SAN LEANDRO UNIFIED SCHOOL DISTRICT
FACILITIES AND CONSTRUCTION – BOND DEPARTMENT

To: Facilities and Technology Committee Meeting on
Date: *10/30/19*
From: Bond Department
Date: *10/23/19*
Re: **Wilson Modular Classroom Building Change Order #2**
Project Description: **18-29**

Change Order

Project: **Wilson Modular Classroom Building**
Woodrow Wilson Elementary School
1300 Williams St.
San Leandro CA 94577

PARTIAL DSA POWER PLAN

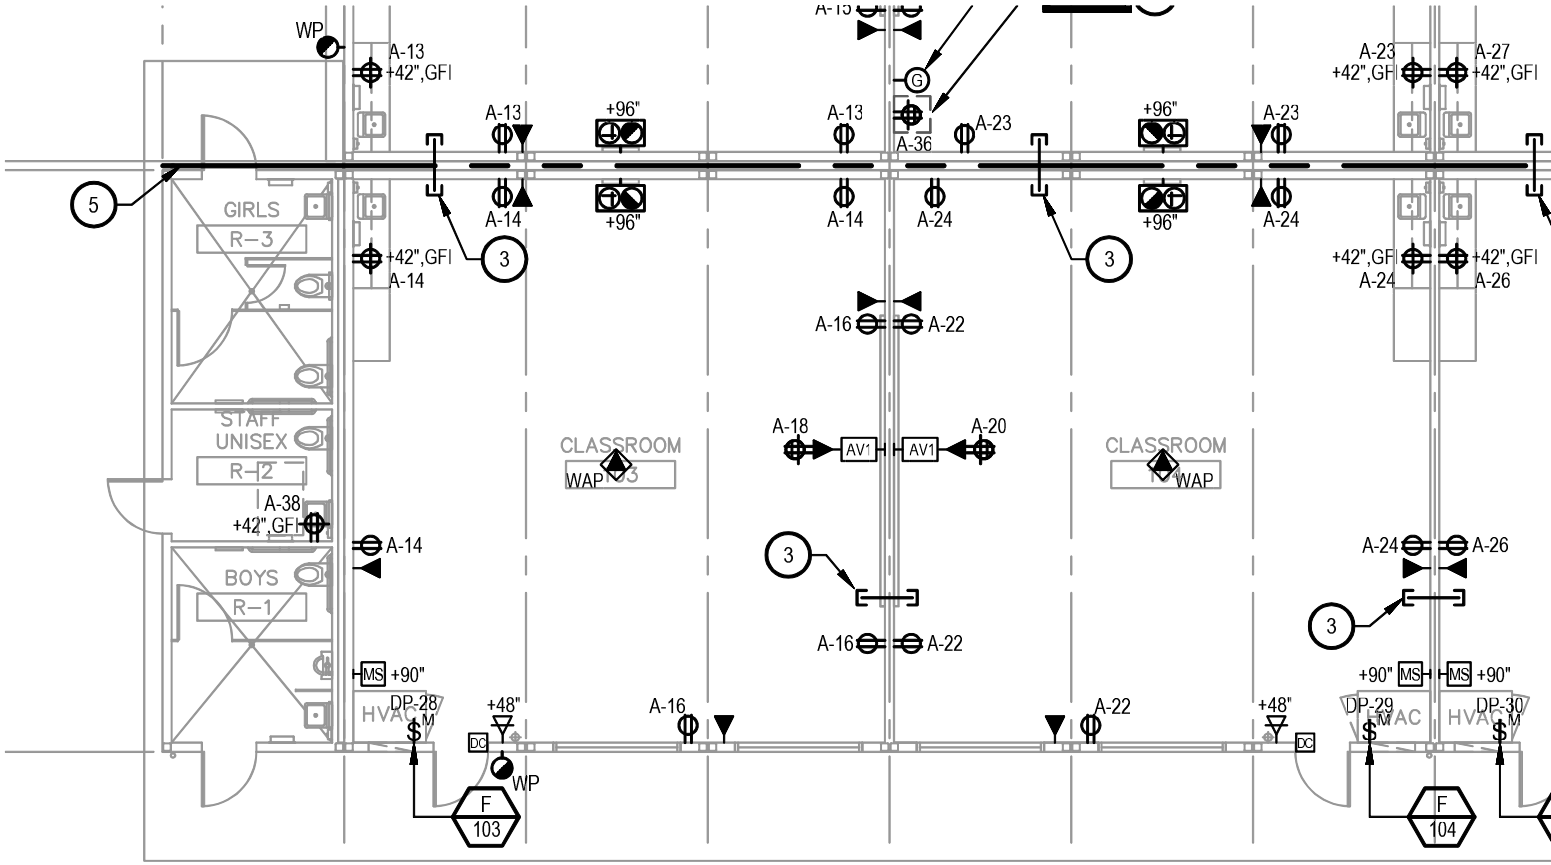
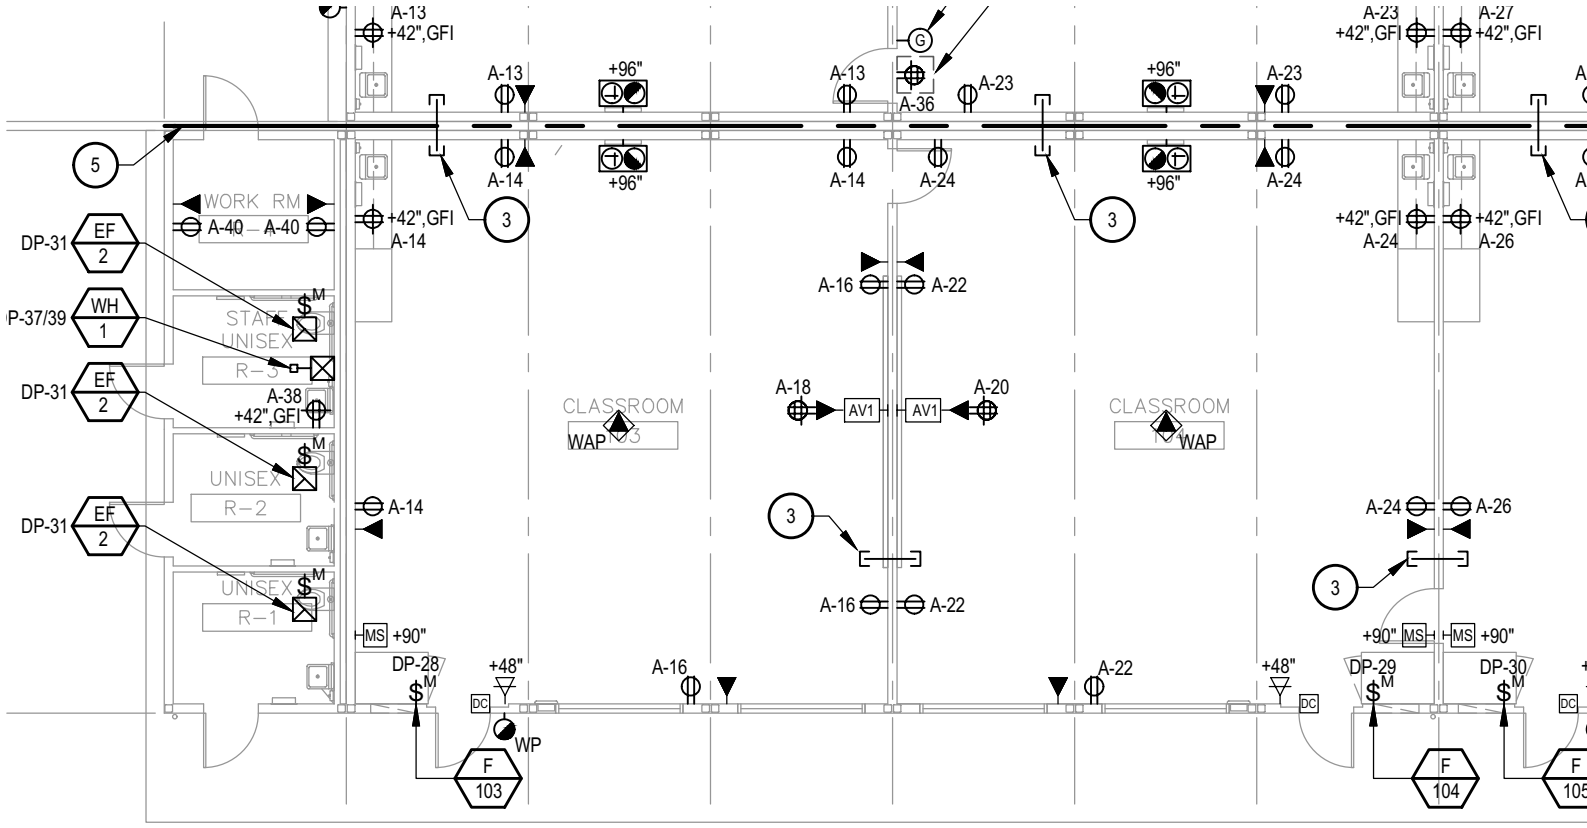
C/O Number:	2	**Comments**
Sequence:	0	ADDED POWER & DELETE FIXTURE AT RESTROOMS
Owner C/O No:	W2 CCD

1 EACH GFCI OUTLET

PARTIAL CCD POWER PLAN

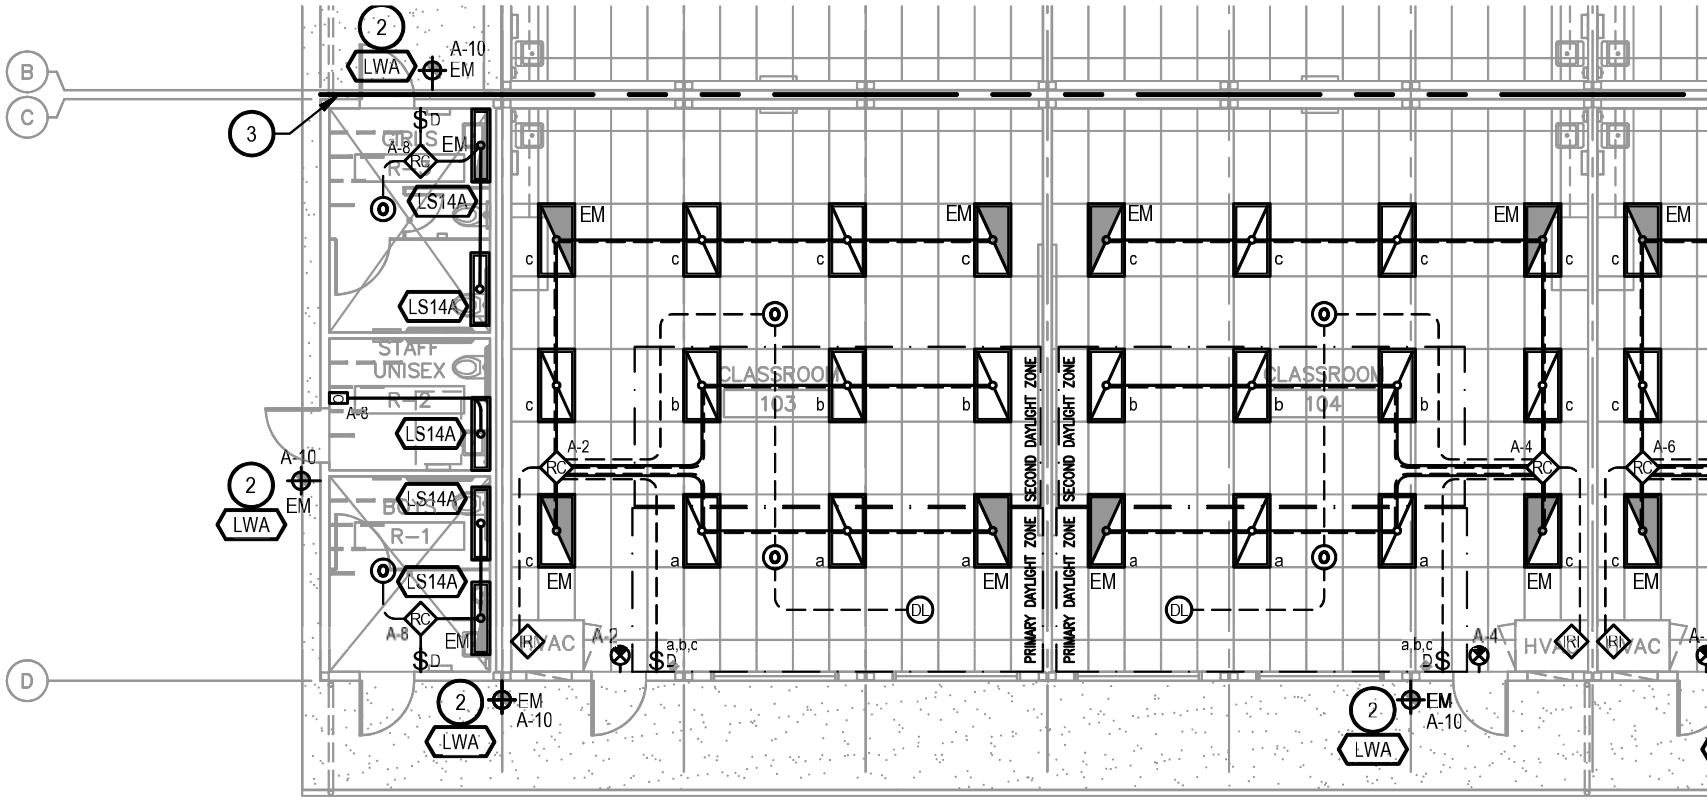
1 EACH GFCI OUTLET
2 EACH OUTLETS
3 EACH POWER TO EF's
1 EACH POWER TO WH1

PARTIAL CCD LIGHTING PLAN

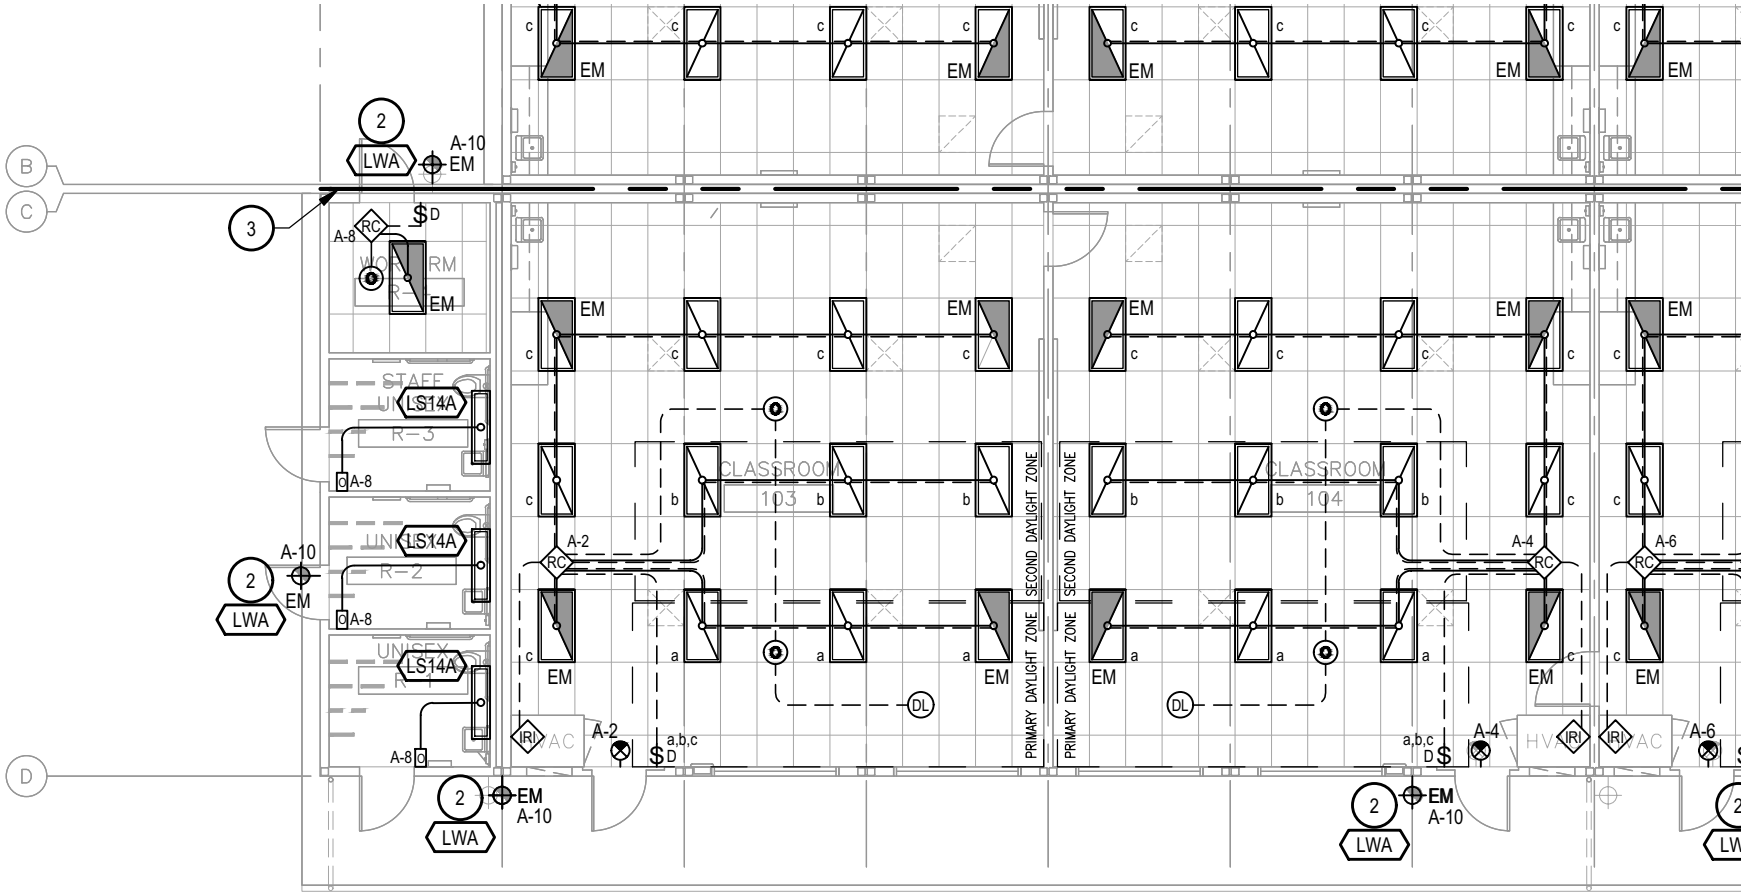
3 EACH LS14A
1 EACH LR24A

C3.1

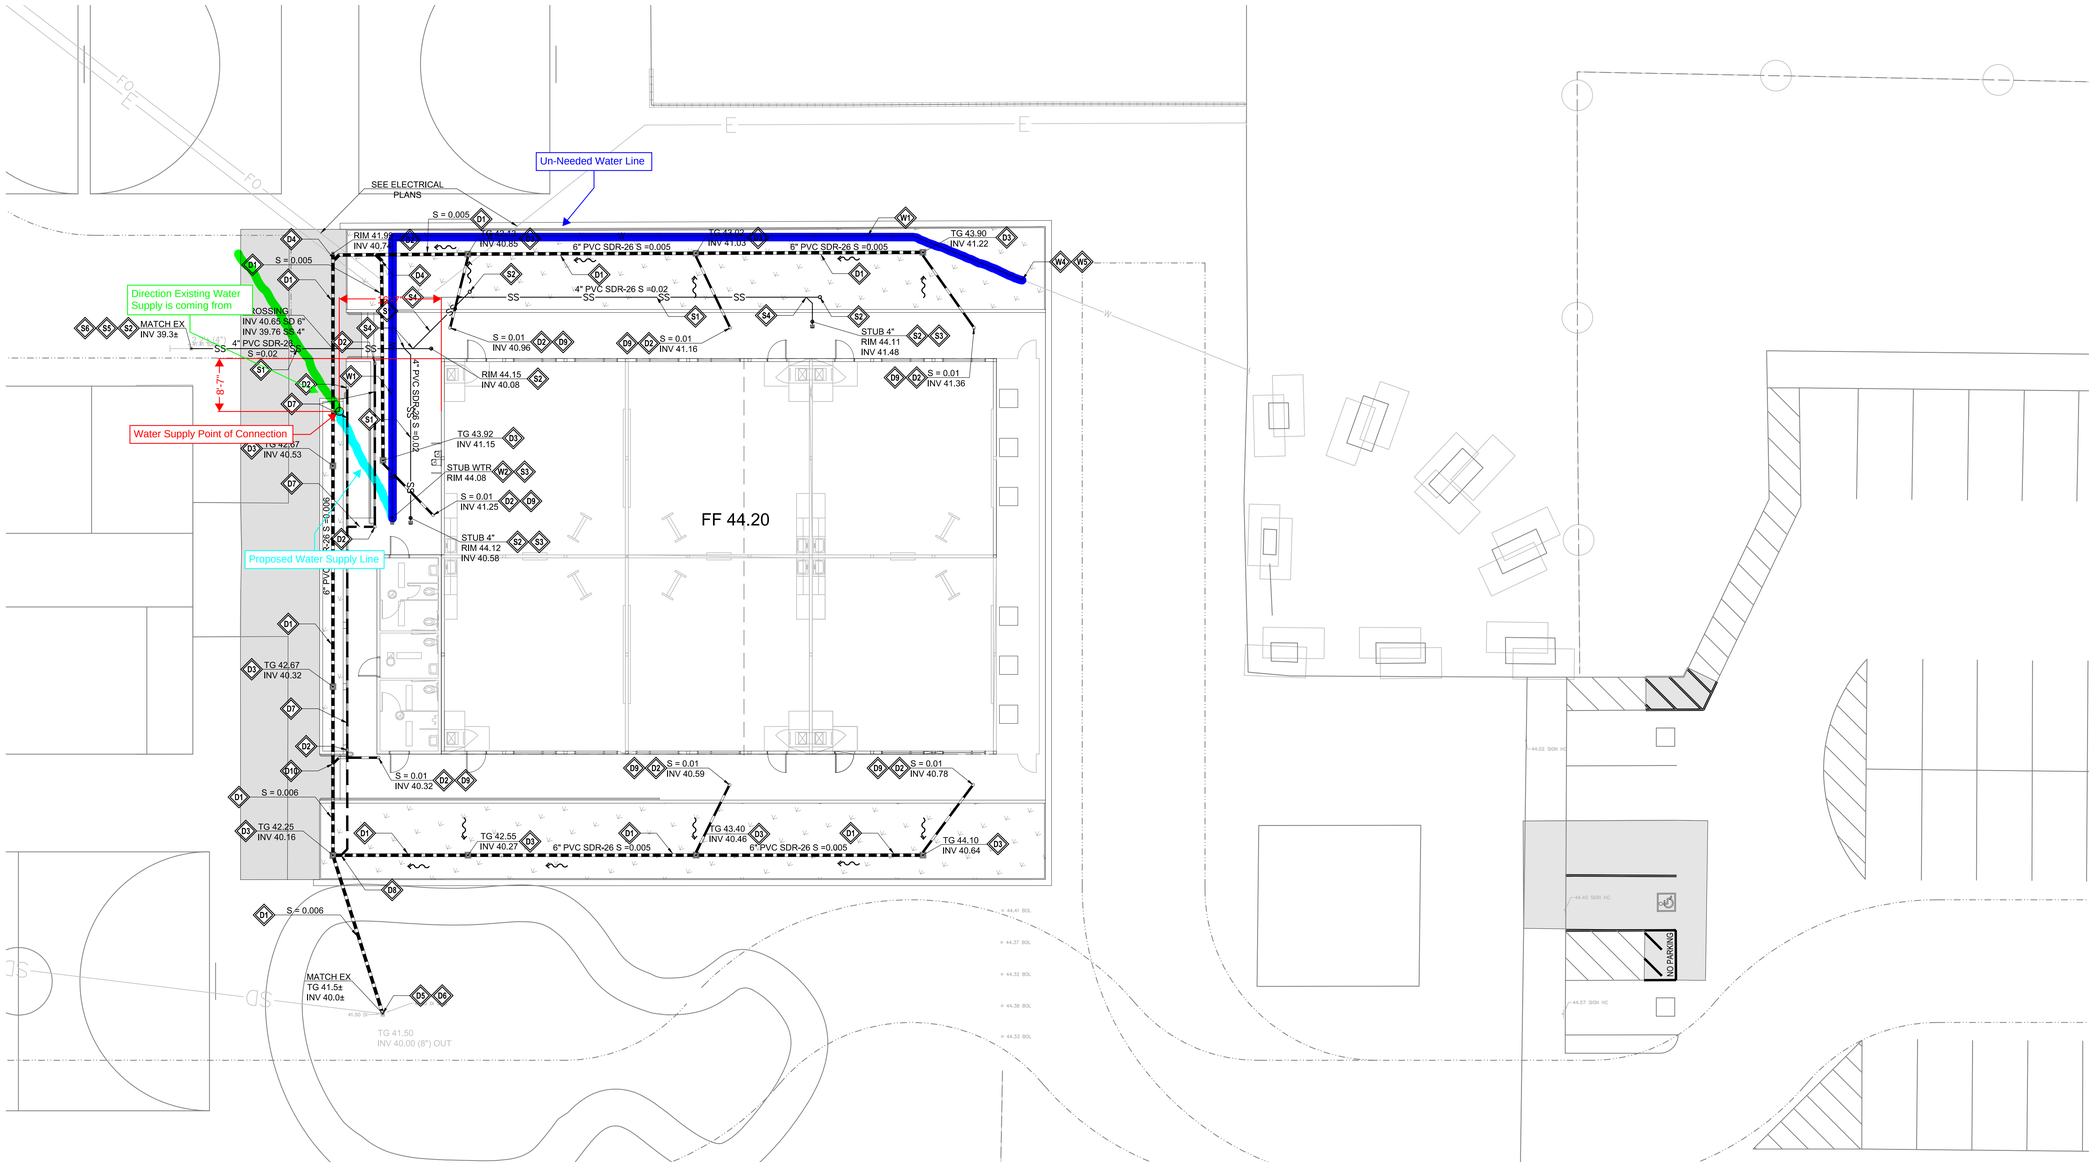
Civil Drawing C3.1 shows POC to upstream connection, the change is for POC to be to downstream connection. See RFI #010

Construction docs show water line connecting at what is in fact the upstream connection point.The water line to new building and existing portables needs to be connected to the downstream POC as identified on site per the attached photo

Per Wilson Increment #1 - C3.1 Utility Plan calls out for the water supply point of connection to be at the North West corner of the building. It was discovered the water supply point of connection is at the South West Corner of the building.
We propose connecting directly from the POC to the buildings 5' waterline, see attached drawing highlighted in light blue.The proposed water supply line highlighted in dark blue is not needed.

We agree with new water alignment.
By: KC, 2019-09-24
